ADDENDUM NO. 3

FROM: Christopher J. Stritzel, P.E.
Crawford, Murphy & Tilly, Inc.

RE: Legacy Pointe Town Center
First Addition – Bid Package No. 1
Springfield, IL

DATE: February 23, 2010

**Typical Bike Path West End of
 Lincolnshire and Lindbergh**

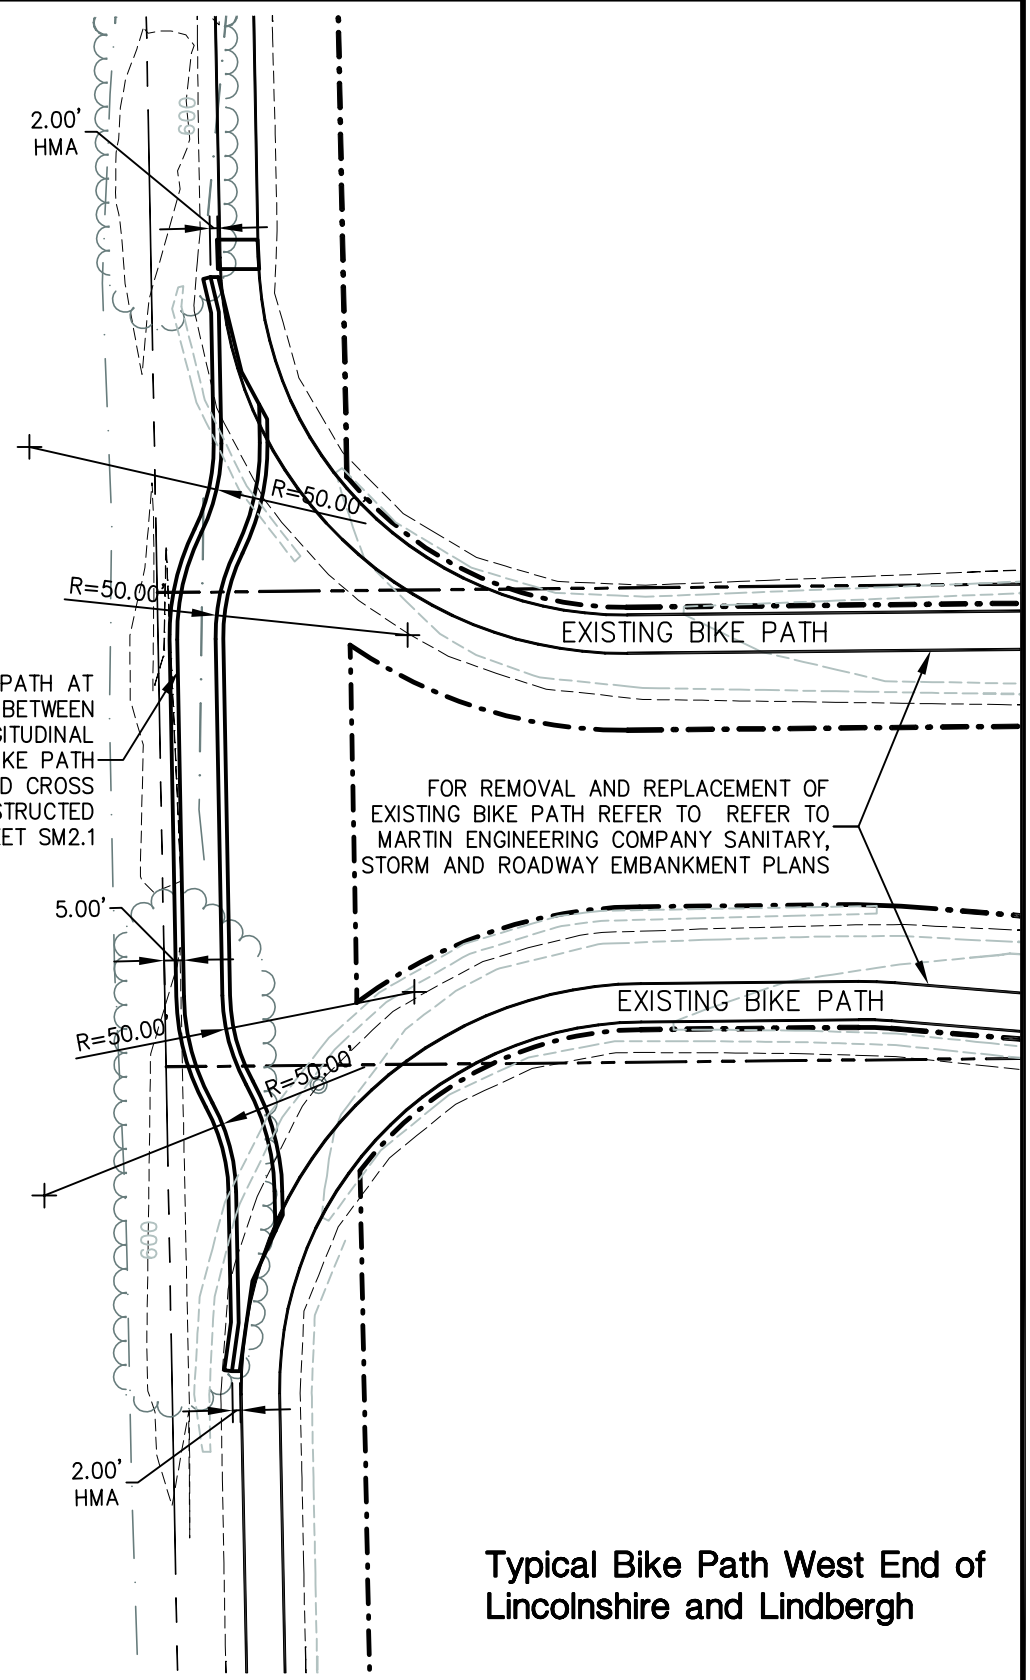
2. Sheet SM1.4, SM 1.6, SM 1.8 & SM 2.1 Detail 7 – Additional details for the temporary bike trail at the west ends of Lincolnshire & Lindbergh have been included. The contractor will be required to build the temporary trail to the details and specs shown on the attachment to this addendum.

CONSTRUCT TEMPORARY BIKE PATH AT
 UNIFORM LONGITUDINAL SLOPE BETWEEN
 TIE IN LOCATIONS. MAXIMUM LONGITUDINAL
 SLOPE SHALL NOT EXCEED 5%. BIKE PATH
 WIDTH, THICKNESS, MATERIAL AND CROSS
 SLOPE SHALL BE CONSTRUCTED
 ACCORDING TO DETAIL 7 SHEET SM2.1

FOR REMOVAL AND REPLACEMENT OF
 EXISTING BIKE PATH REFER TO REFER TO
 MARTIN ENGINEERING COMPANY SANITARY,
 STORM AND ROADWAY EMBANKMENT PLANS
